## Product Change Notice (PCN)

**PCN Number:** PCN-0451321R-01

**Product(s) Affected:** PDP-40

### Old Design

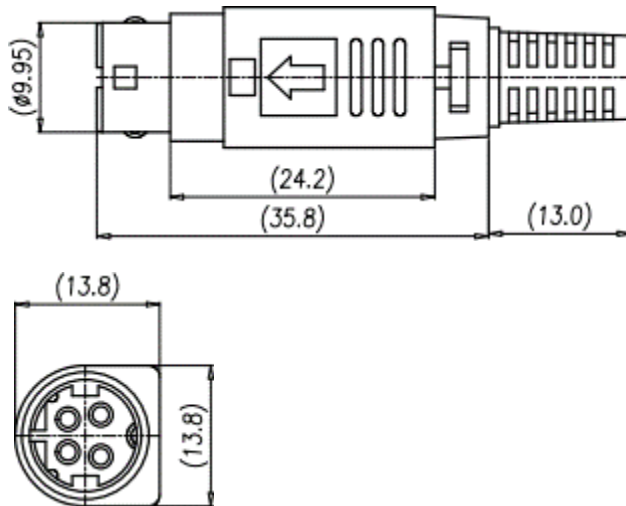
**Description of Change:** housing and materials changes as shown below.

MATERIAL	PLATING
OUTER HOOD	ABS	
METAL SLEEVE	Brass	Nickel
CLAMP	Brass	Nickel
PIN/BODY	Brass/PBT	Silver
PLASTIC RING	POM	
METAL COVER	Brass	Nickel
SPRING	Steel	
INNER HOOD	ABS	
STRAIN RELIEF	PVC

MATERIAL	PLATING
housing	PBT (UL94V-0)	
contacts	copper alloy	silver
plastic cover	ABS	
metal shell	copper alloy	nickel
metal cap	copper alloy	nickel
cable fixer	copper alloy	tin
ring	POM	
spring	steel	nickel
plastic tube	ABS	
SR	PVC
